Access Compliance Report

Main Street: HEWES_ST Cross Street: E_SILVERLEAF_AVE Location: NE

ADA ID: RPRK211223113914 Ramp Type: Type 1 - Perpendicular Diagonal Initial Pass/Fail: Pass Overall Compliance: No Severity Score: 0

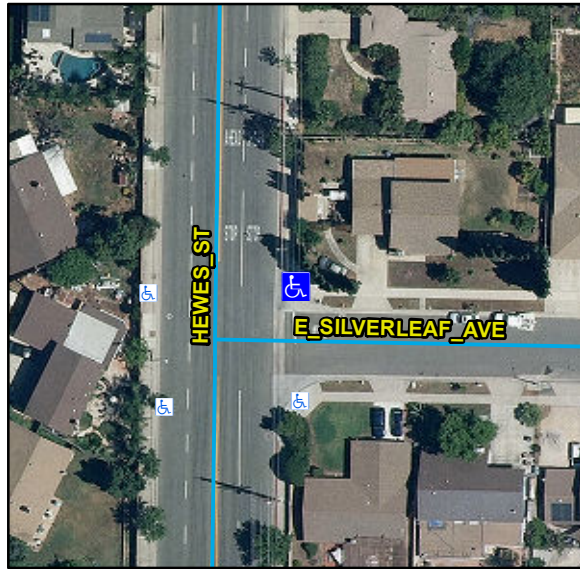
Compliance	Description	Data	Compliance	Description	Data
N/A	Ramp Length (in)	76	N/A	Flare Type LT	
Yes	Ramp Width (in)	50			Sloped
Yes	Ramp Run Slope (%)	7.2	Yes	Flare Slope LT (%)	9
Yes	Ramp Cross Slope (%)	0.2	N/A	Flare Traversable LT	Yes
N/A	Landing Present	Yes	N/A	Flare Type RT	
N/A	Landing Length (in)	48			Sloped
Yes	Landing Width (in)	48	N/A	Flare Slope RT (%)	3.8
Yes	Landing Run Slope (%)	1.2	N/A	Flare Traversable RT	No
Yes	Landing Cross Slope (%)	0.3	Yes	DWS Provided	Yes
N/A	Landing Movement Obstructed?	Yes	Yes	DWS Contrast	Yes
	Landing Movement Type	Curb	Yes	DWS Length (in)	36
N/A	Landing Shared	No	Yes	DWS Full Width	Yes
N/A	Clear Space	Yes	Yes	DWS Offset Left (in)	0
N/A	Clear Space To Crosswalk (in)	48	Yes	DWS Offset Right (in)	N/A
N/A	Marked Crosswalk 1	No	N/A	Marked Crosswalk 2	No
	Crossing 1 Direction	W		Crossing 2 Direction	S
	Marked Crosswalk 1 Width (in)	N/A		Marked Crosswalk 2 Width (in)	N/A

Remove & Replace Landing.

R304.2.1, STD 1115
